Staff Report PC20-28-DP

Fishback Creek Fleet Shop- Development Plan

Docket PC20-08-DP Development Plan- The petitioner is requesting review of a Development Plan to be known as Fishback Creek 3 Fleet Shop at the northeast corner of CR 450 E and Albert S White Drive in Whitestown. The site is zoned I-1, a light industry zone with a portion zoned I-65 South Corridor Overlay. The petitioner is proposing to construct an approximate 15,000 square foot building footprint, fleet maintenance shop with parking on an approximate 3.93 acres. The petitioner is GDI Construction and owner is Indhland, LLC

SITE PLAN

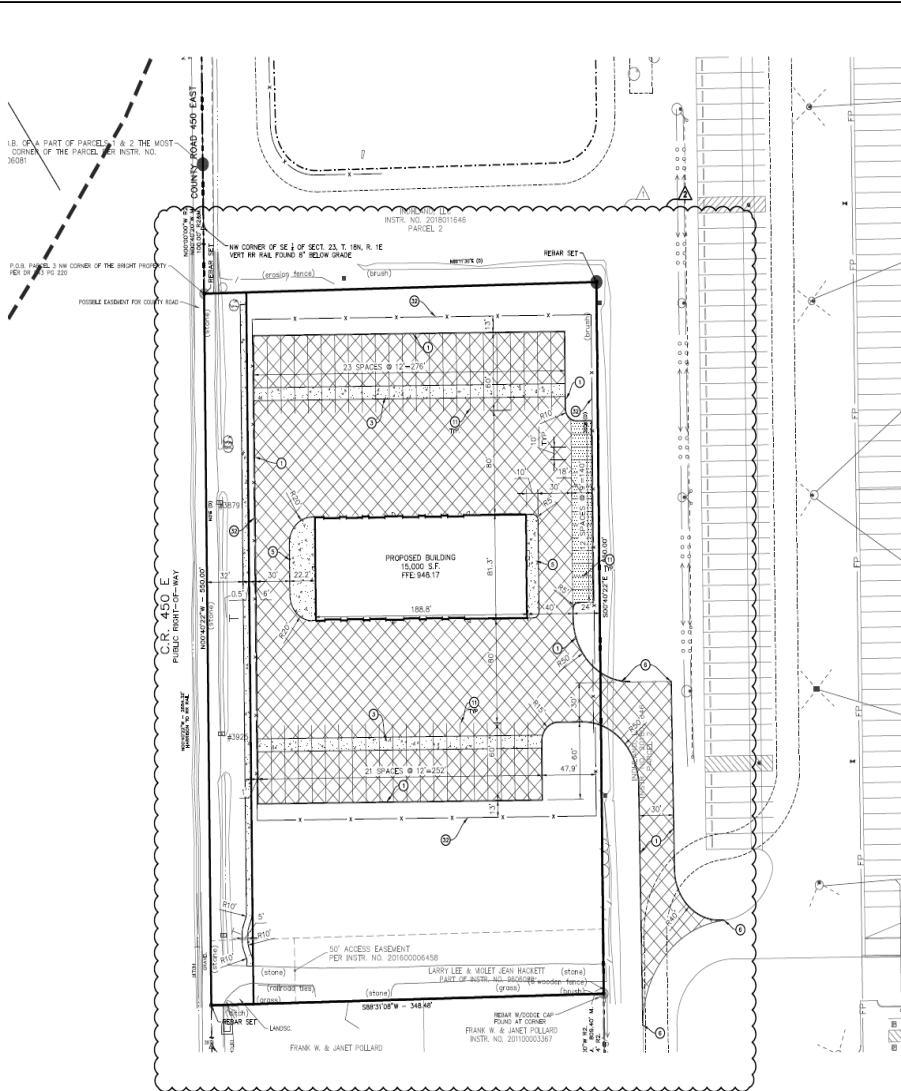
The site plan provided shows 15 vehicular spaces, the petitioner has stated one stall will be removed and only 14 spaces will be provided as requested in the waiver.
